CITY OF LEE'S SUMMIT, MISSOURI
220 S.E. GREEN STREET
LEE'S SUMMIT, MISSOURI 64063
(816) 969-1800

Pryor Road Improvements
Federal Project No. STBG 3378 (403)
City Project No. 571

ADDENDUM NO. #1

DETOUR PLAN NORTH PHASE N2

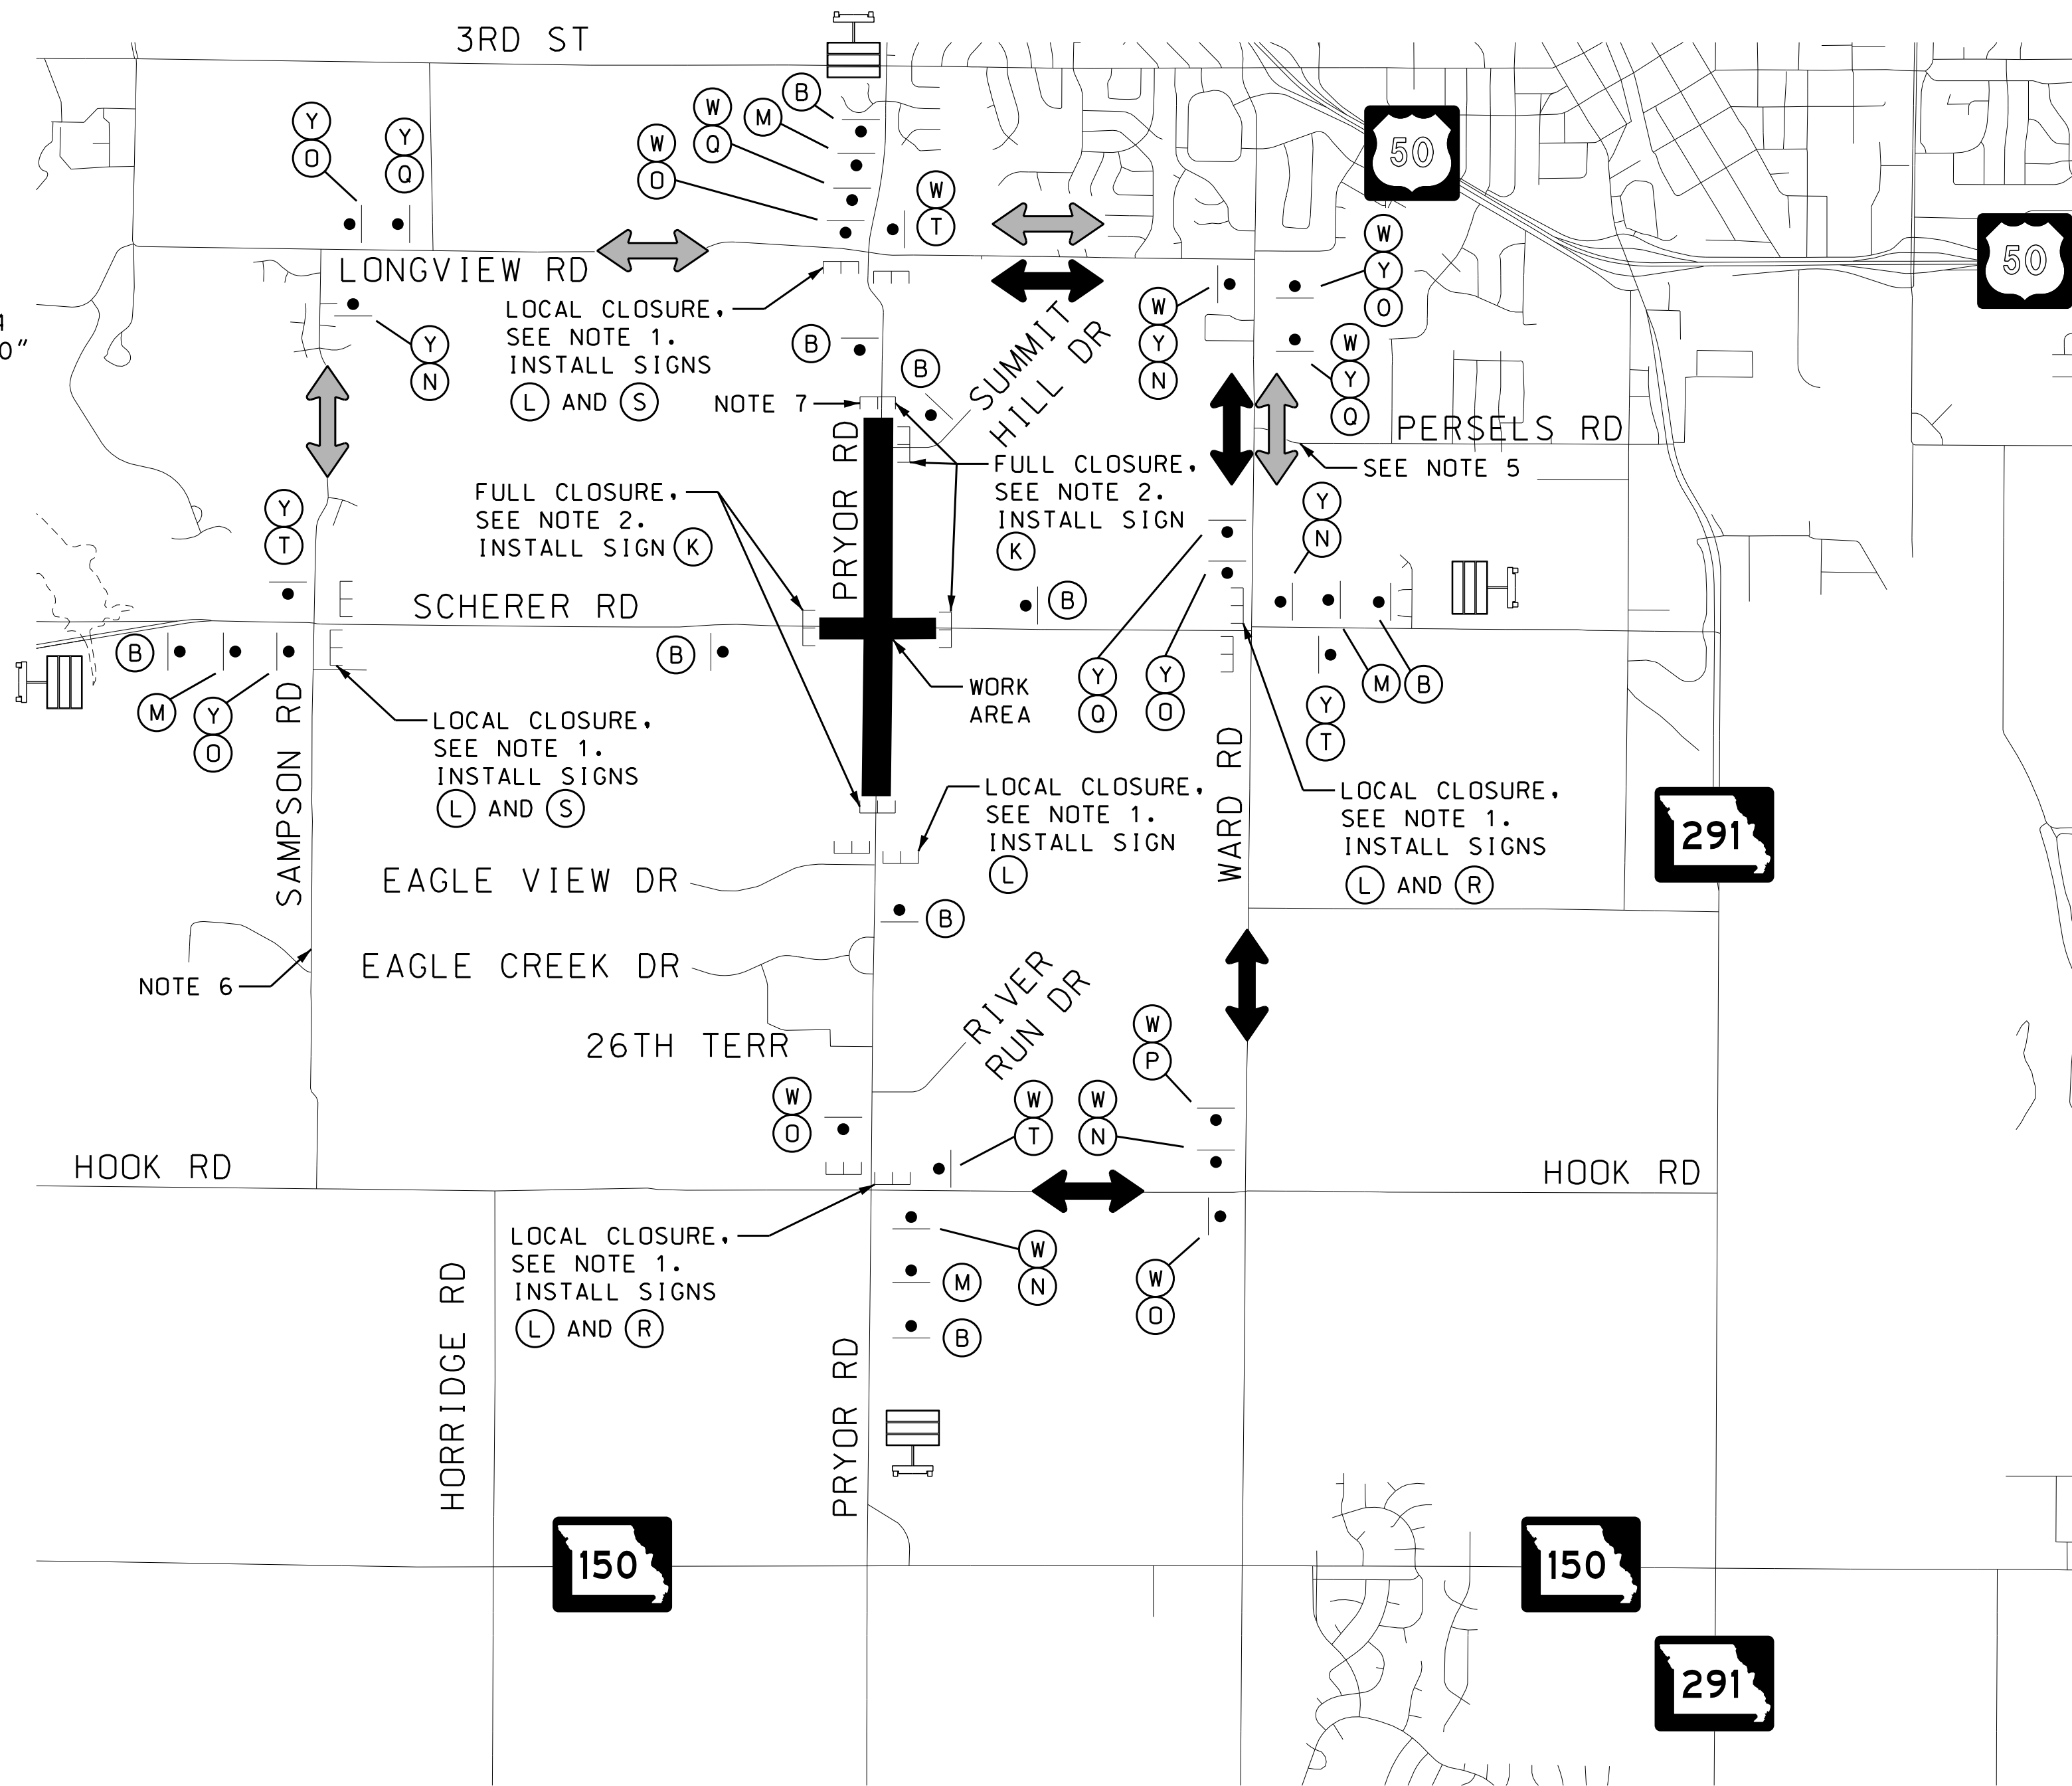
1. Remove and replace duplicate sheet 217 “Detour Plan South Phase” with attached sheet 219 “Detour Plan North Phase N2”. Sheet 219 was previously not included in the plans and in its place sheet 217 had mistakenly been inserted again.
2. Remove and replace sheet 218 “Detour Plan North Phase N1”, dated 06/28/2024, with attached sheet 218 “Detour Plan North Phase N1”, dated 10/10/2024. A changeable message sign was added for NB traffic.
3. Remove and replace sheets 2, 5 and 6, dated 6/30/2024 of the “Pryor Road 16” Water Main Replacement & Relocation” plans, with attached sheets 2, 5 and 6, dated 10/8/2024. Missing water main connections were addressed.
4. Remove and replace sheet 3 of 7, dated 9/27/2024 of the “Transmission Main Relocations” plans with attached sheet 3 of 7, dated 10/16/2024. Informational table was added and Item No. 2’s quantity was updated.

DETOUR PLAN
NORTH PHASE N1

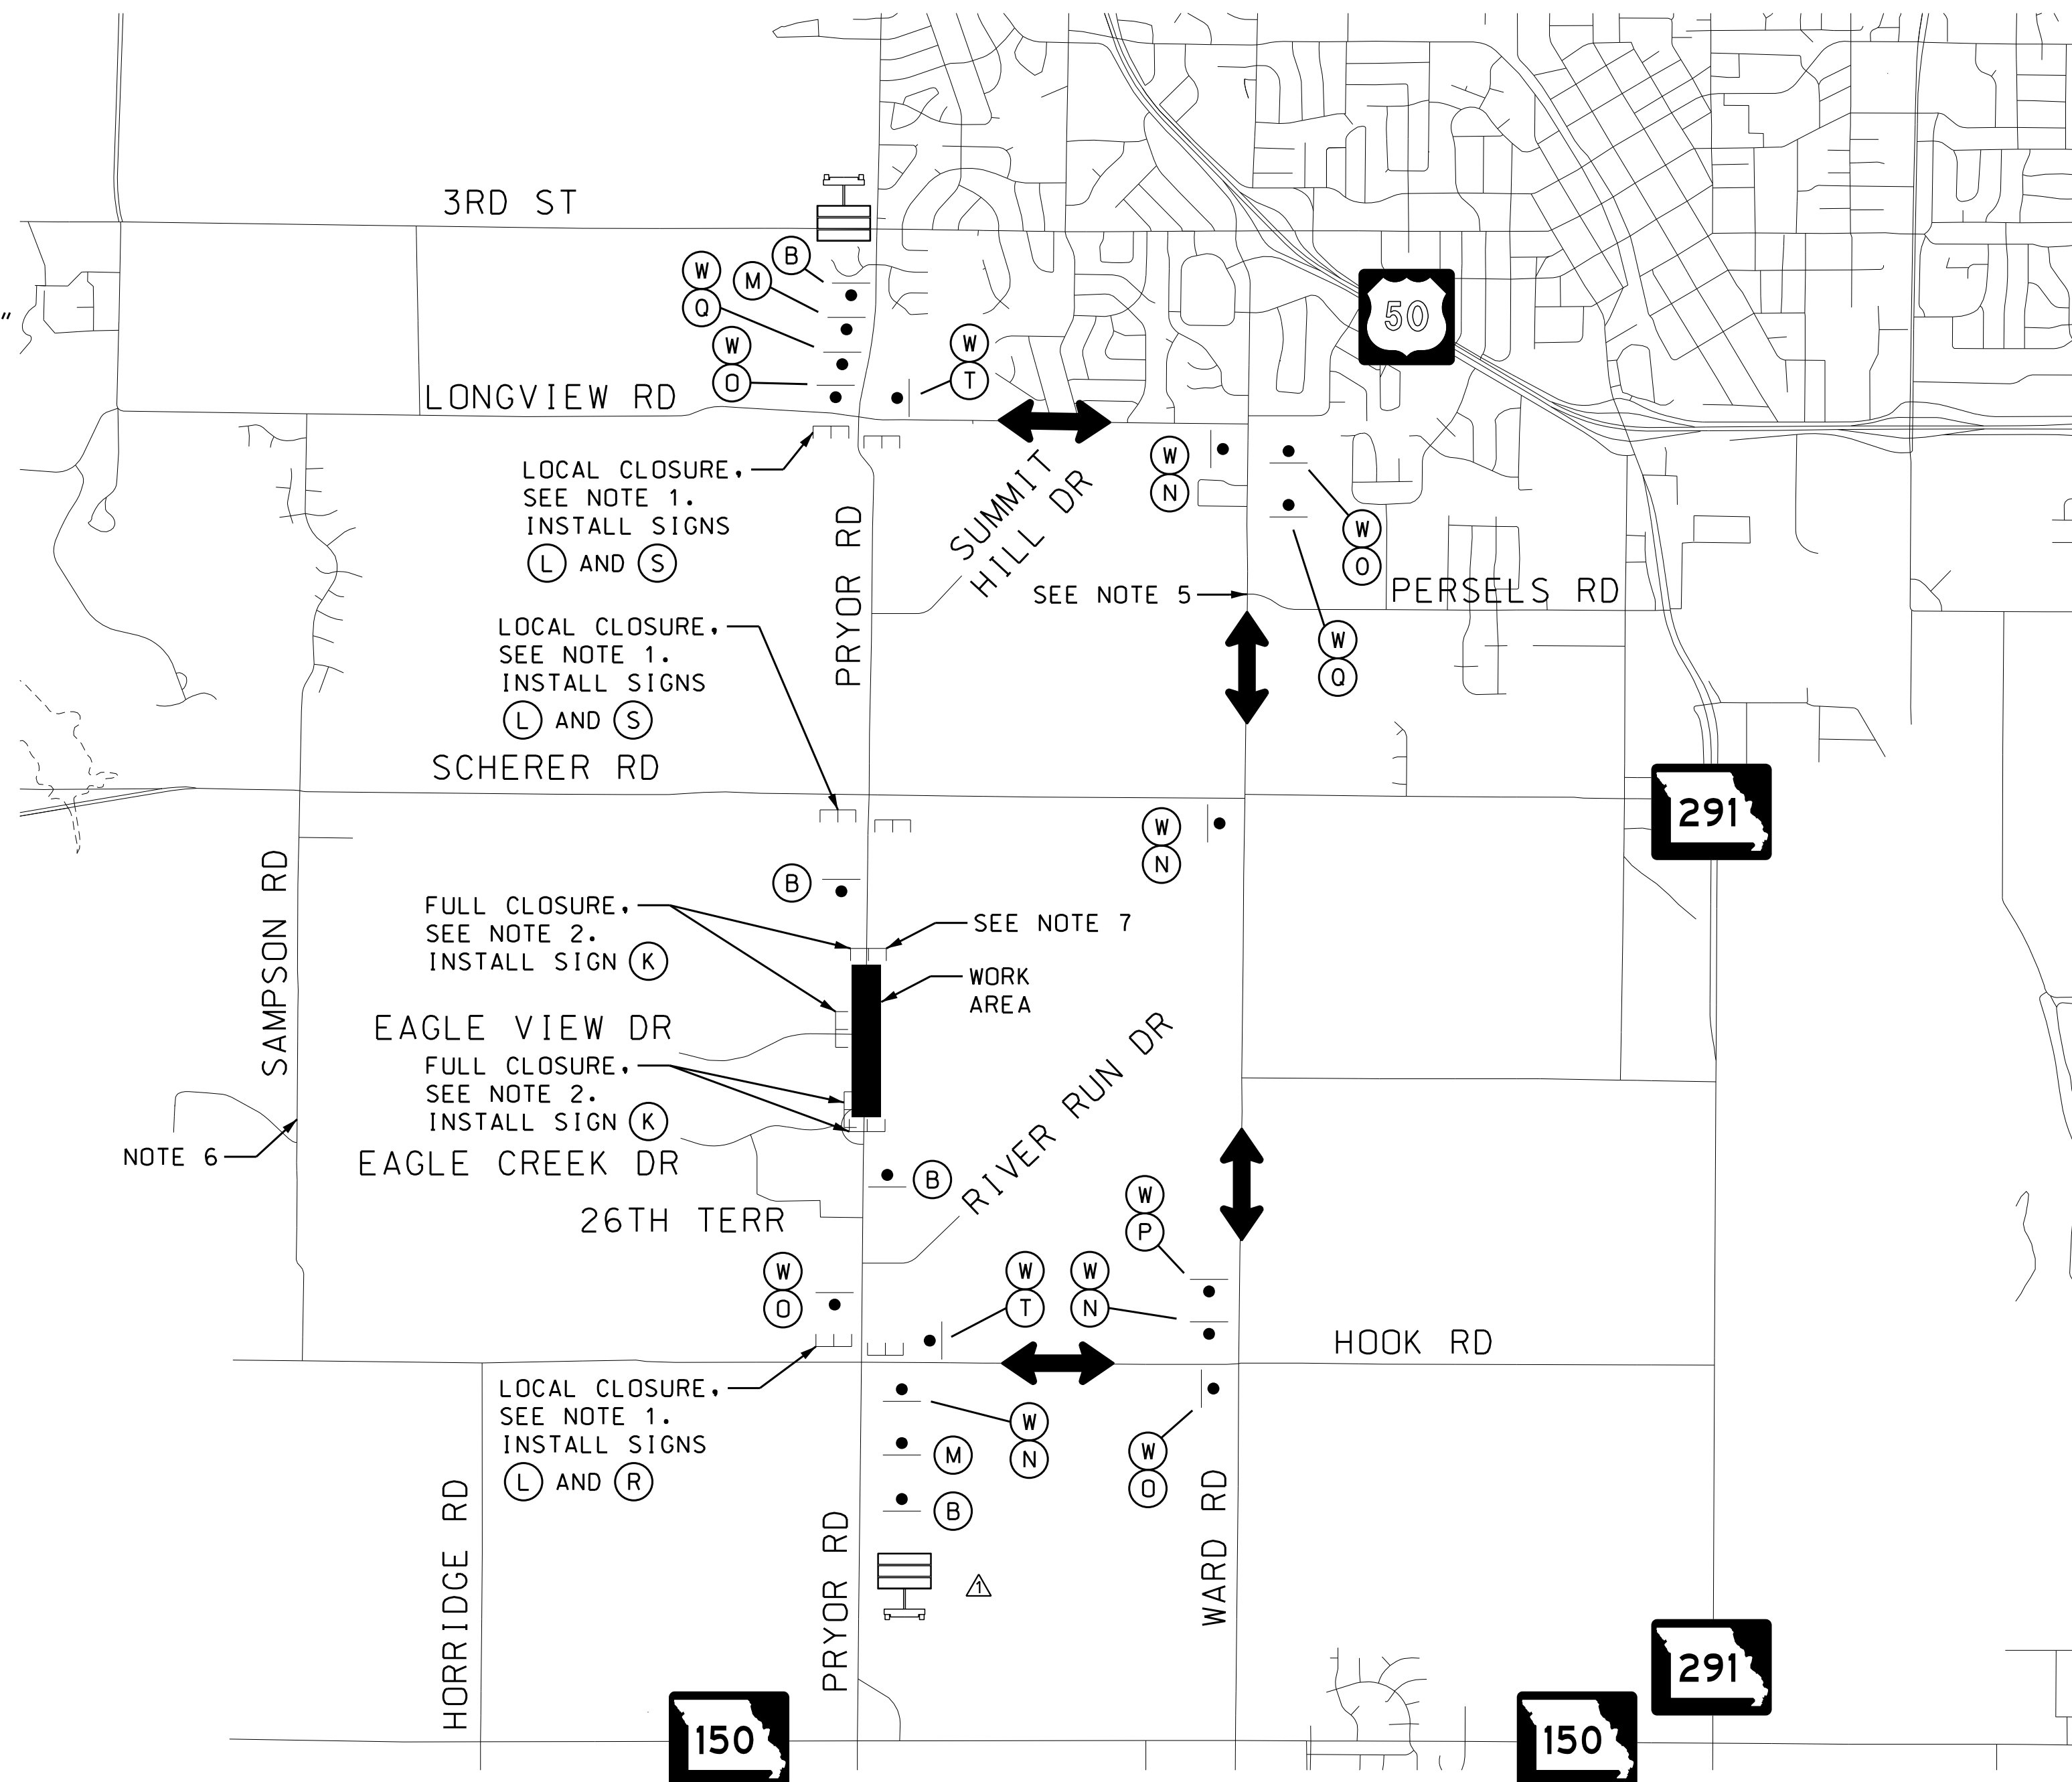
DATE	DESCRIPTION	ADDED CHANGEABLE MESSAGE SIGN, NB.
10/10/24
